Technical Memorandum

Project: City of Reedsport Rail Crossing Study and Refinement Plan

RE: Tech Memorandum #8: Amendments and Implementing Measures

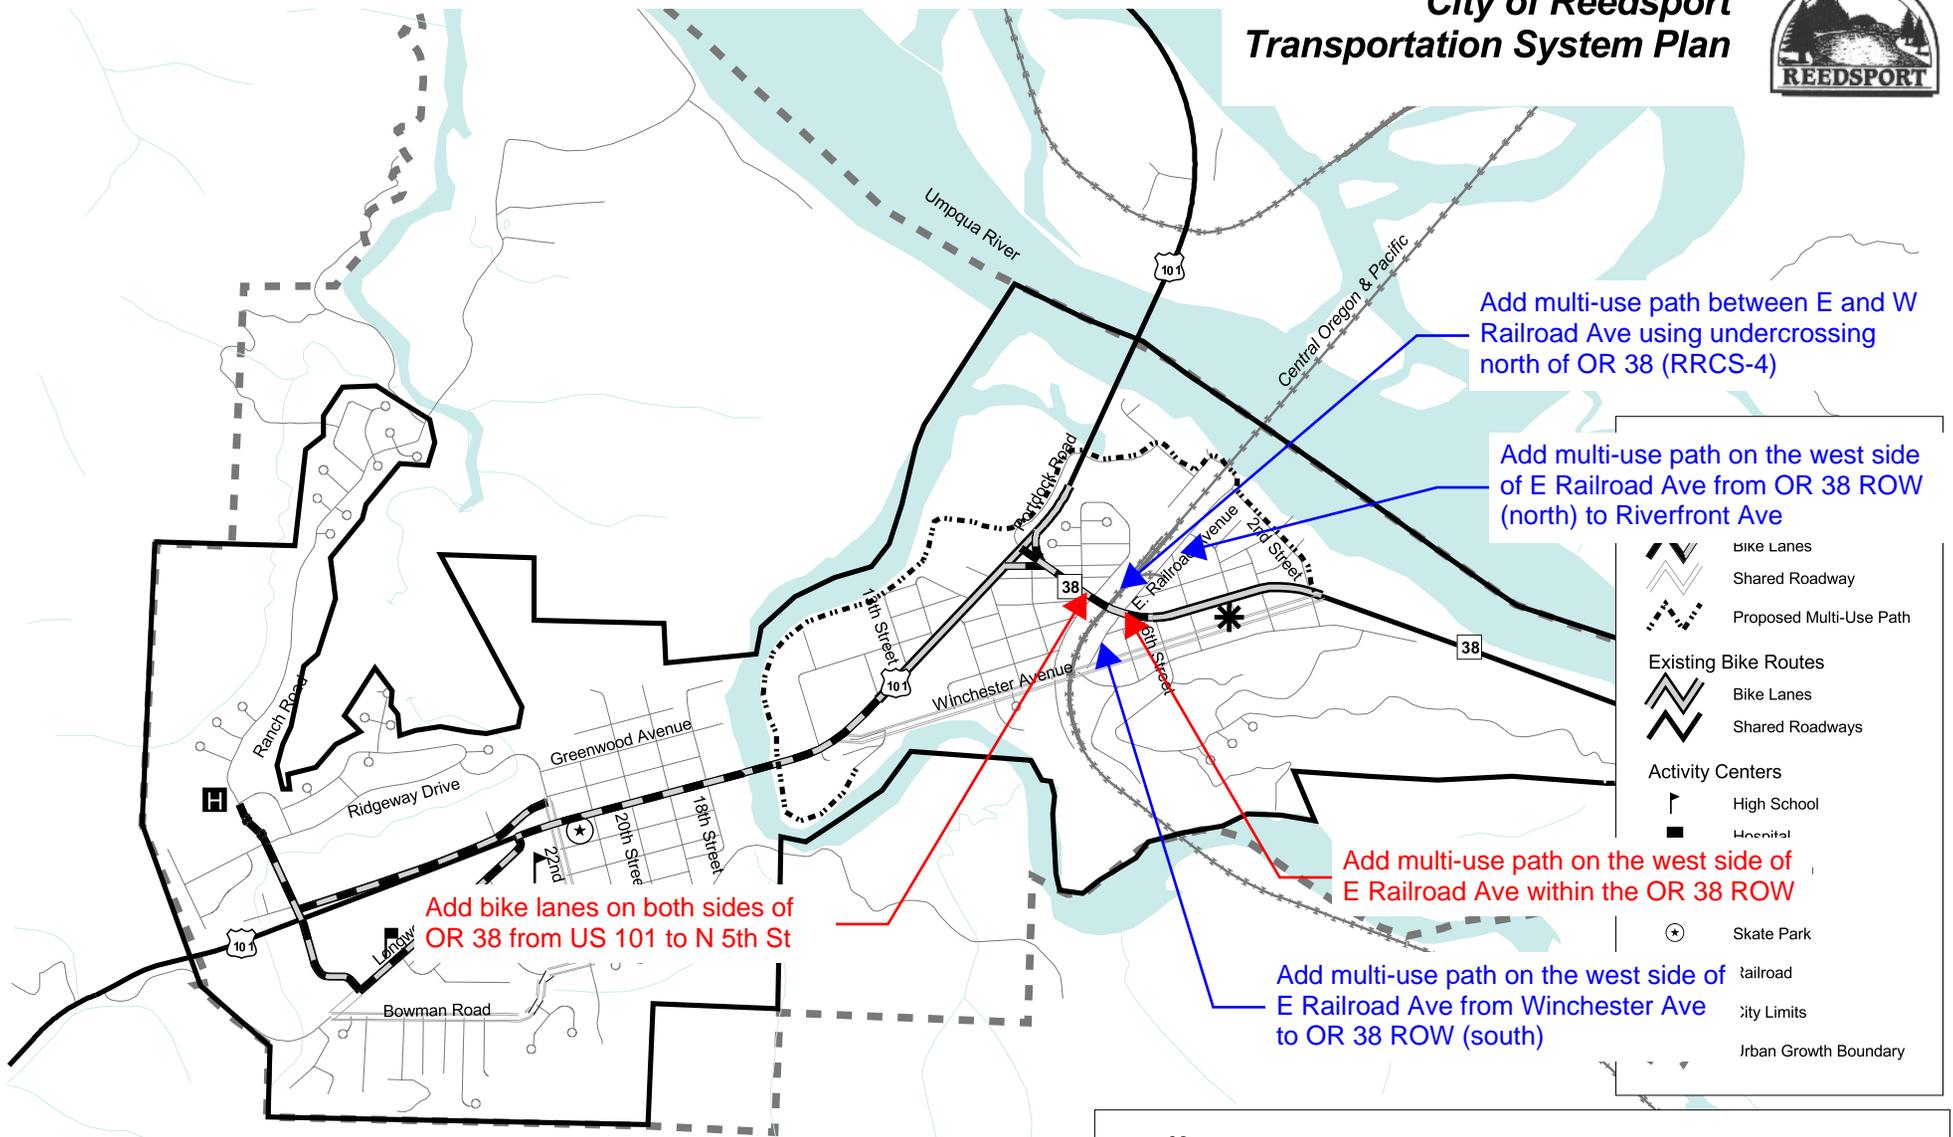
The projects shown in Table 1 are part of the Pacific Coast Multimodal Port mitigations and intended to improve pedestrian access and circulation with implementation of the OR 38 overcrossing. All the projects shown in Table 1 should be incorporated into the TSP as an amendment or with the next TSP update. *Attachment A contains a redlined version of Figure 5-1 that shows the amendments in red.*

The projects shown in Table 2 are intended to complement the mitigations and further improve pedestrian access and circulation in downtown Reedsport. All the projects shown in Table 2 should be incorporated into the TSP as an amendment or with the next TSP update. At that time, the City should determine if any of the projects should be included in the Pedestrian Action Plan. *Attachment A contains a redlined version of Figure 5-1 that shows the amendments in blue.*

**Figure 6-1
BICYCLE MASTER PLAN**

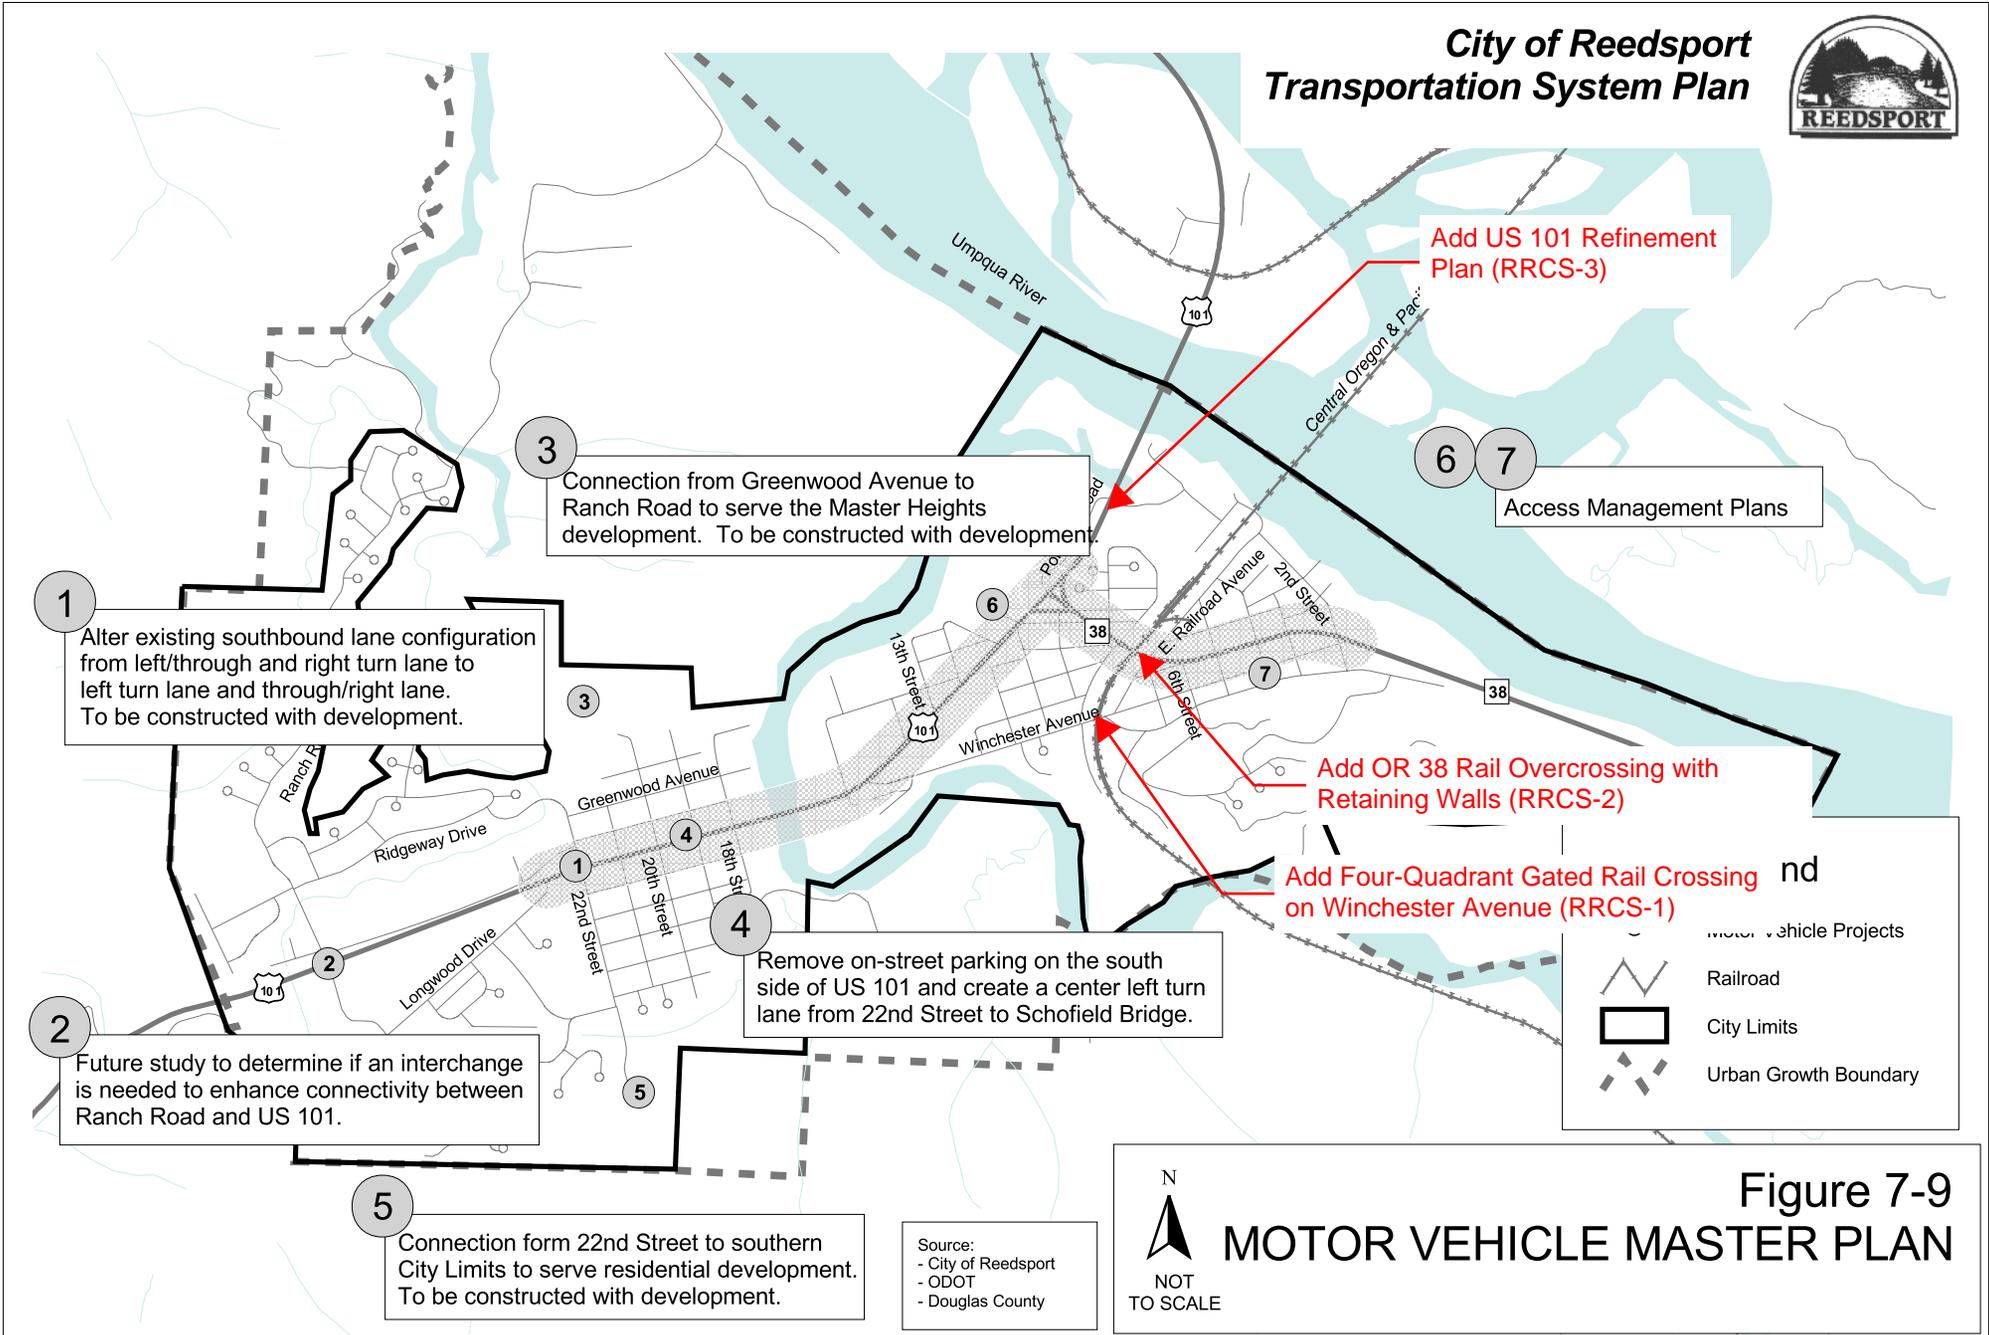
The projects shown in Table 3 are part of the Pacific Coast Multimodal Port mitigations and intended to improve bicycle access and circulation with implementation of the OR 38 overcrossing. All the projects shown in Table 3 should be incorporated into the TSP as an amendment or with the next TSP update. *Attachment A contains a redlined version of Figure 5-2 of that shows the amendments in red.*

The projects shown in Table 4 are intended to complement the Pacific Cost Multimodal Port mitigations and further improve bicycle access and circulation in downtown Reedsport. All the projects shown in Table 4 should be incorporated into the TSP as an amendment or with the next TSP update. At that time, the City should determine if any of the projects should be included in the Bicycle Action Plan. *Attachment A contains a redlined version of Figure 5-2 that shows the amendments in blue.*
